DEVELOPMENT APPLICATION

PROJECT :
RESIDENTIAL DEVELOPMENT

59 CUDGEGONG ROAD, ROUSE HILL,NSW
2155

LEVEL 5

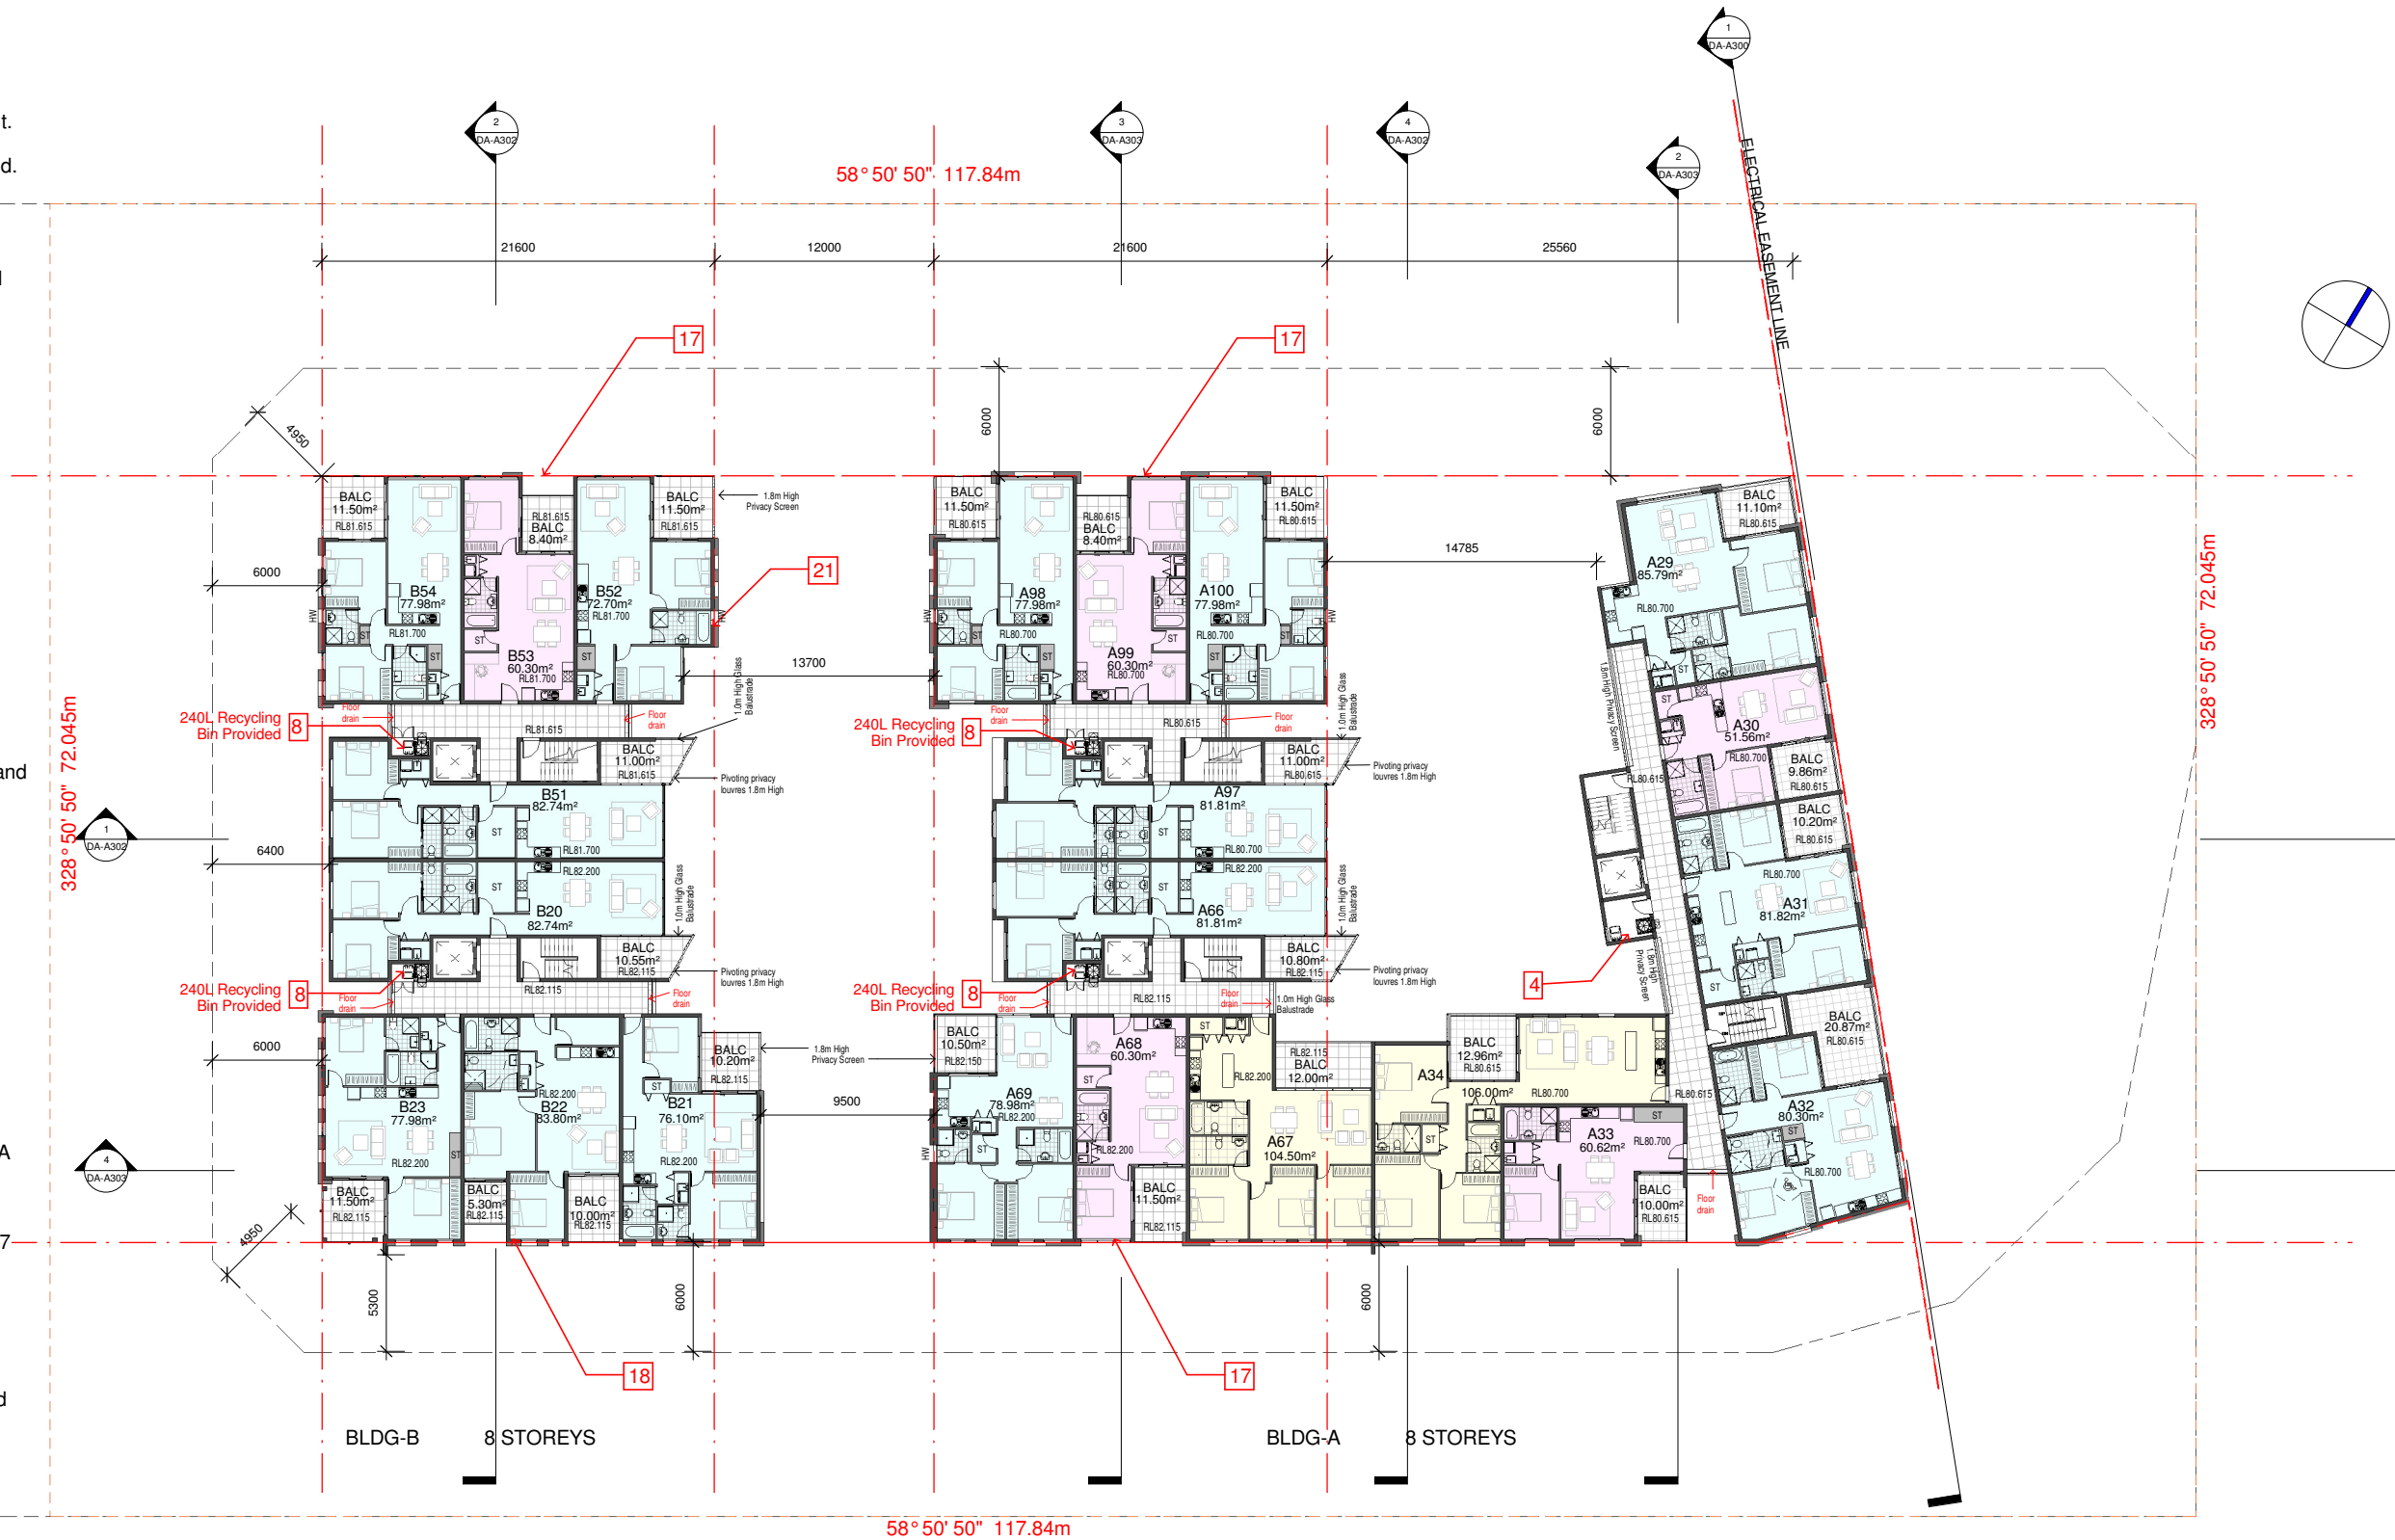
1. Bin travel path with 1.5m wide provided at basement.
2. Removable bollards and a no parking line mark noted.
3. Truck sweep paths of 11.00m long council truck provided.

4. Building-A residents access to recycling bins located at the top of the stair well and adjacent to the lift core from Level 1 and above added.
5. Waste room access adjacent to the driveway ramp relocated.

6. 1.5m wide doorway provided in each bulky waste storage areas and caged enclosure.
7. Driveway ramp gradients adjusted.
8. 240L recycling bins provided

9. Access between bulky goods and waste bin room deleted.
10. Fire stair relocated
11. Lift relocated and Waste room and bulky storage adjusted.
12. Relocate lift, fire stair adjusted and relayout of car and bicycle parkings.

13. Waste room and bulky storage adjusted.
14. Relocated lift core and car and bicycle parking adjusted.
15. Fire stairs adjusted and relocated door access openings.

16. Redesigned Building A to achieved solar access requirements to the communal open space. Fire stairs and lift relocated, access ramp added to access COS and redesigned of the unit layouts.

17. Redesigned of unit layout
A61, A65, A69, A73, A77, A81, A85, A92, A96, A100, A104, A108, A112 and A116.
18. Redesigned of unit layout
B06, B10, B14, B18, B22, B26, B30, B41, B45, B49, B53, B57 and B61.

19. Building A roof plan adjusted and roof overhang deleted.
20. Skylights provided on Unit A45, A76, A77, B30 & B31 but is not included in the solar calculation that recieved minimum 2hrs of sunlight.

21. Adjusted unit layout
B36, B40, B44, B48, B52, B56, and B60
22. Adjusted layout-bulk storage and waste room
23. Adjusted bin layout

SHEET TITLE:
LEVEL 7
DESIGN:
NS
DRAWN:
AJRSA
DATE:
JUNE 2016
SCALE:
AS SHOWN

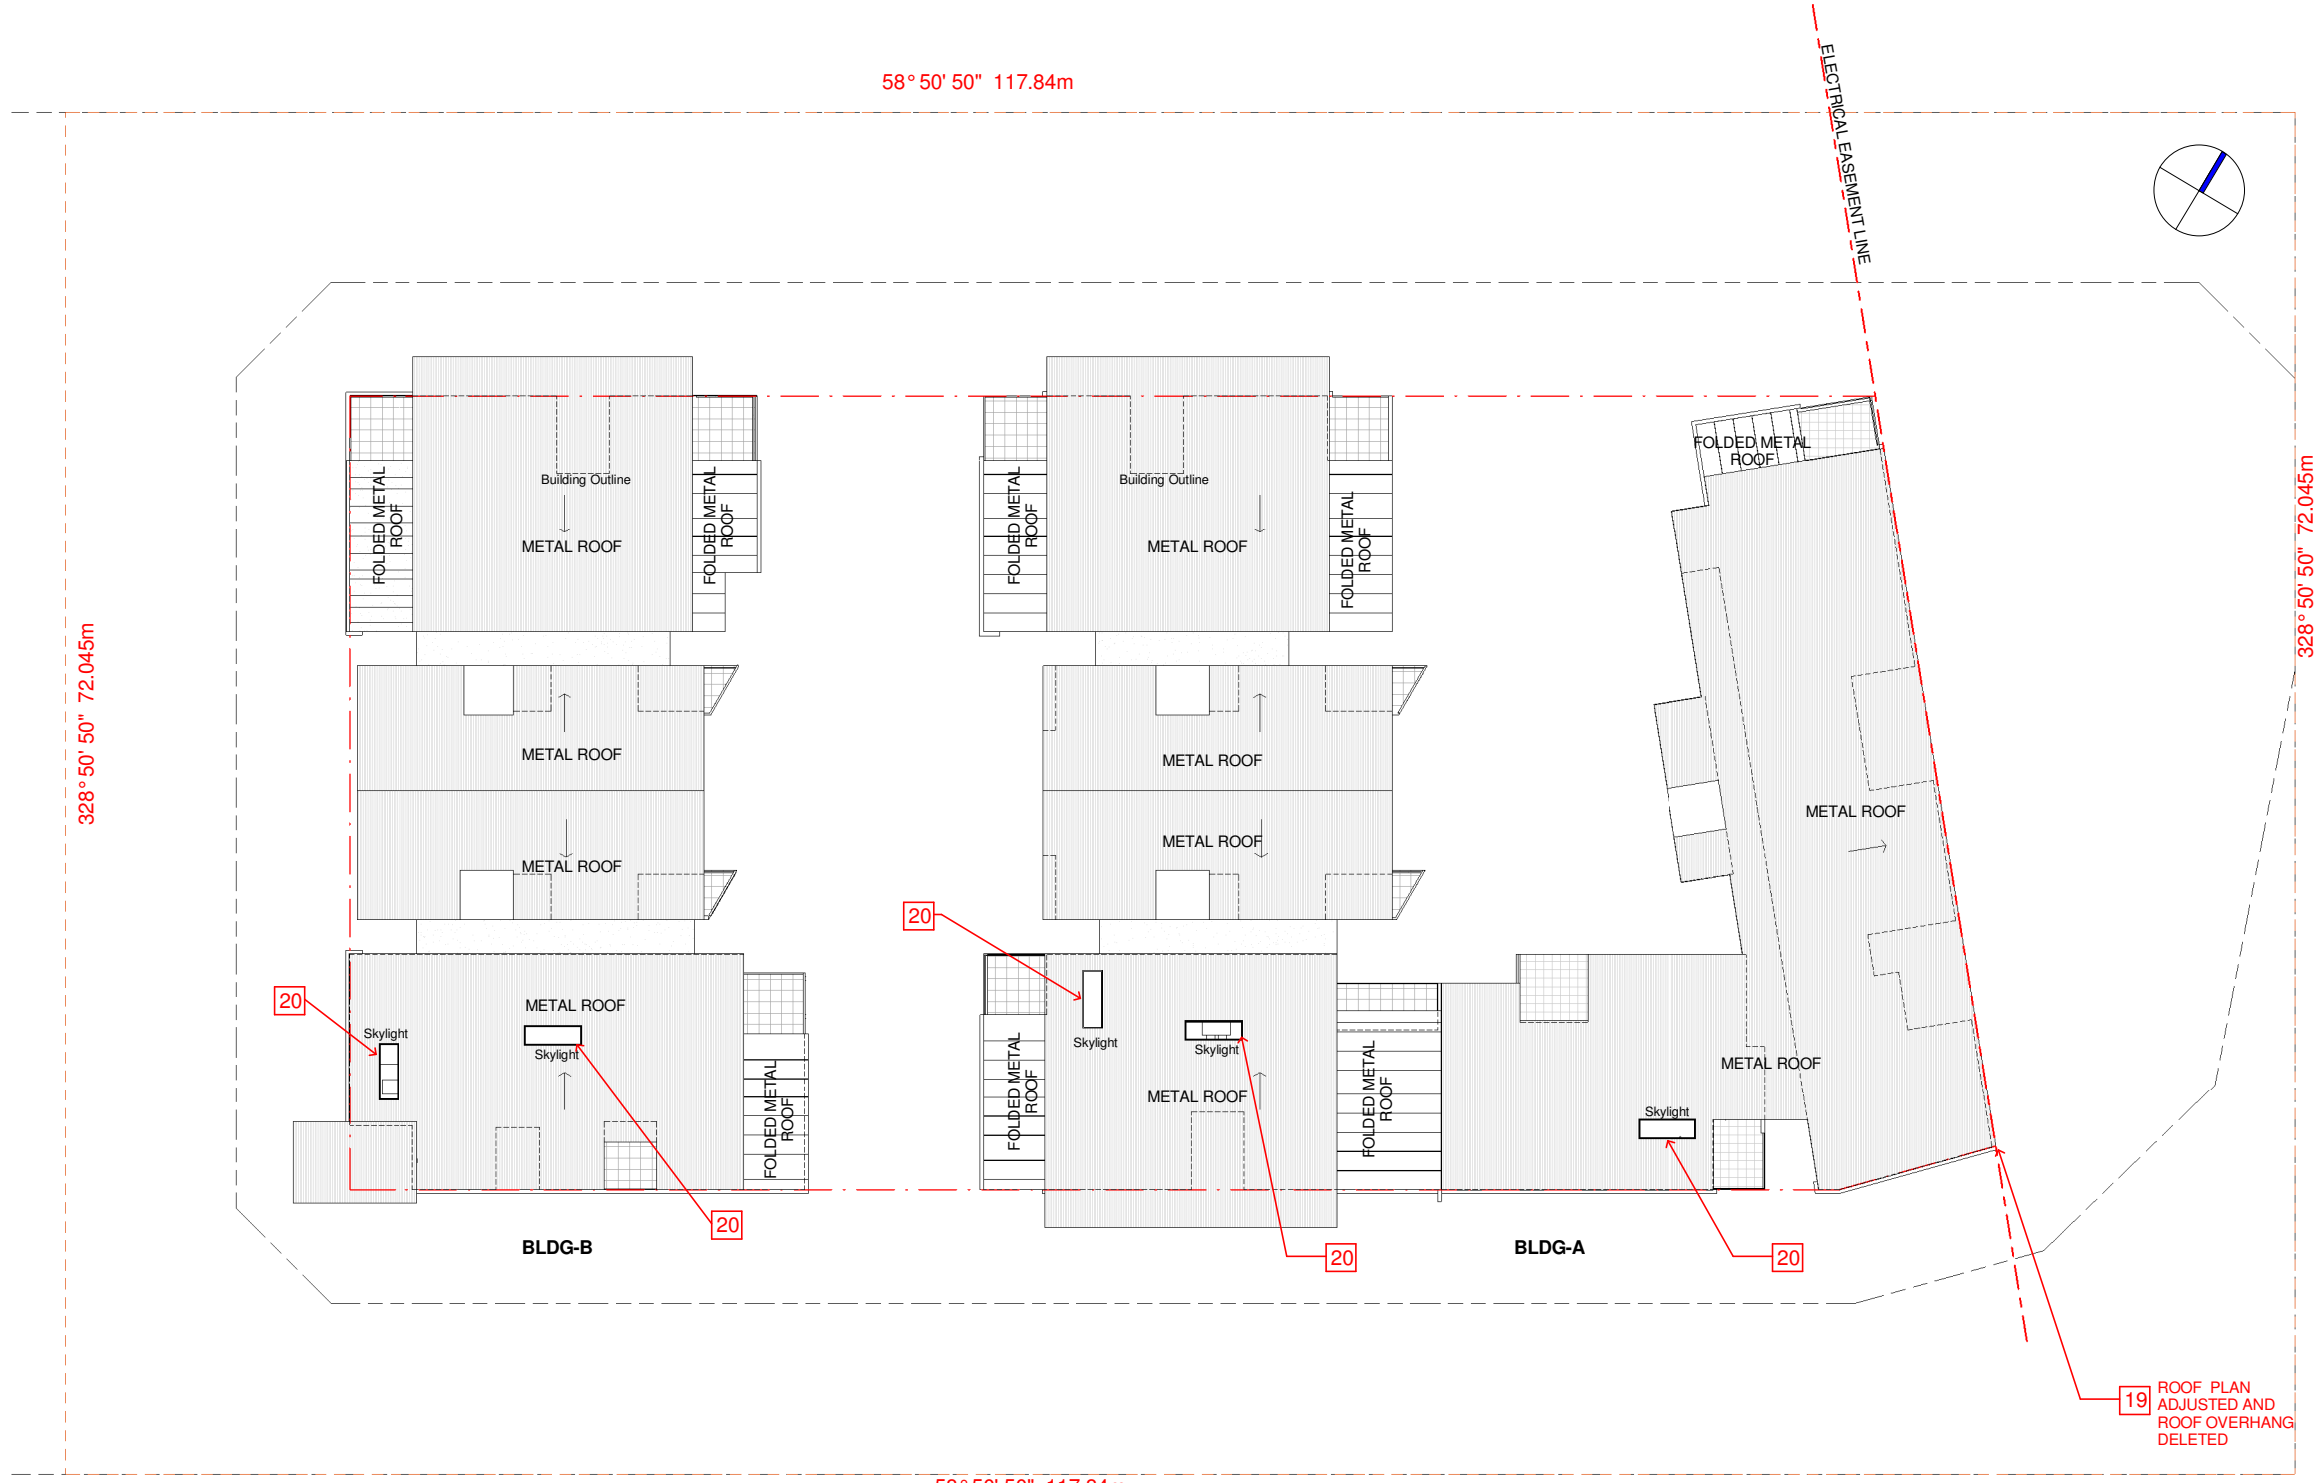
1. Bin travel path with 1.5m wide provided at basement.
- 2.Removable bollards and a no parking line mark noted.
- 3.Truck sweep paths of 11.00m long council-truck provided.

- 4.Building-A residents access to recycling bins located at the top of the stair well and adjacent to the lift core from Level 1 and above added.
- 5.Waste room access adjacent to the driveway ramp relocated.

- 6.1.5m wide doorway provided in each bulky waste storage areas and caged enclosure.
7. Driveway ramp gradients adjusted.
8. 240L recycling bins provided

- 9.Access between bulky goods and waste bin room deleted.
10. Fire stair relocated
- 11.Lift relocated and Waste room and bulky storage adjusted.
- 12.Relocate lift, fire stair adjusted and relayout of car and bicycle parkings.

- 13.Waste room and bulky storage adjusted.
- 14.Relocated lift core and car and bicycle parking adjusted.
- 15.Fire stairs adjusted and relocated door access openings.

- 16.Redesigned Building A to achieved solar access requirements to the communal open space. Fire stairs and lift relocated,access ramp added to access COS and redesigned of the unit layouts.

17. Redesigned of unit layout
A61,A65,A69,A73,A77,A81,A85,A92,A96,A100,A104,A108,A112 and A116.
- 18.Redesigned of unit layout
B06,B10,B14,B18,B22,B26,B30,B41,B45,B49,B53,B57 and B61.

- 19.Building A roof plan adjusted and roof overhang deleted.
- 20.Skylights provided on Unit A45,A76,A77,B30& B31 but is not included in the solar calculation that recieved minimum 2hrs of sunlight.

- 21.Adjusted unit layout
B36,B40,B44,B48,B52,B56,and B60
22. Adjusted layout-bulk storage and waste room
23. Adjusted bin layout
